#355-22 and #356-22

PUBLIC HEARING MEMORANDUM

SUBJECT: **Petition #355-22** Request to Rezone 11 Florence Street SUNRISE DEVELOPMENT, INC petition to rezone 2 parcels as follows: 11 Florence Street (Section 82 Block 04 Lot 49) from MULTI RESIDENCE 1 to BUSINESS USE 4; and 318 Boylston Street (Section 82 Block 04 Lot 47) from BUSINESS USE 2 to BUSINESS USE 4.

Petition #356-22 to allow Elder Housing with services, to allow a development in excess of 20,000 sq. ft., to allow a five-story building, to allow a retaining wall greater than 4' in height within a setback, to allow free-standing signs, to allow parking within the front setback, and to waive lighting requirements at 11 Florence Street and 318 Boylston Street, Ward 8, Newton, on land known as Section 82 Block 04 Lots 47 and 49, containing approximately 82,946 sq. ft. of land in a district zoned BU2 (318 Boylston Street, to be rezoned to BU4) and MR1 (11 Florence Street, to be rezoned to BU4). Ref: Sec. 7.3.3, 7.4, 4.4.1, 6.2.10, 4.1.2.B.1, 4.1.2.B.3, 4.1.3, 5.4.2.B, 5.1.8.A.1, 5.1.13, 5.1.10.A, 5.2.13 of the City of Newton Rev Zoning Ord, 2017.

Proposed Site Plan

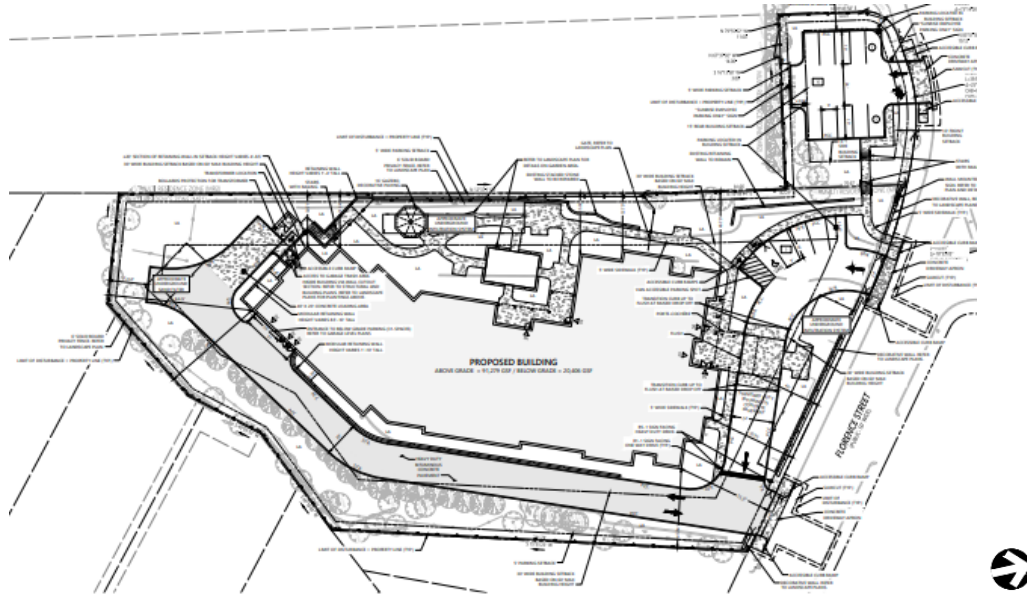
In the business zones, the required setbacks are the equivalent of half of the building height. With a proposed building height of 60 feet, the required front, side, and rear setbacks are 30 feet. As proposed, the front setback will be 40 feet from the front property line to the porte-cochere over the pick-up/drop off driveway. The proposed side setbacks are 30.71 feet from the right side (western) property line and 45.94 feet from the left side (eastern) property line, which abuts residential uses. The proposed rear setback is 84.23 feet, exceeding the 30 feet required

Parcel A will be used as a ten-stall surface parking facility and have an internal non-vehicular connection to the site via an internal path and set of stairs due to the grade change of approximately 10 feet between Parcels A and B.

There is a proposed retaining wall along the right (western) side property line and rear of the building. The plans submitted indicate portions of a retaining wall reach a height of eight feet within the side setback. The wall that reaches a height of eight feet is at the rear of the building with the wall along the property line ranging from less than a foot to four feet. There is a portion of the wall which exceeds eight feet but is outside of the side setback.

At the rear of the proposed building between the building and right property line is a transformer screened by landscaping and protected by bollards.
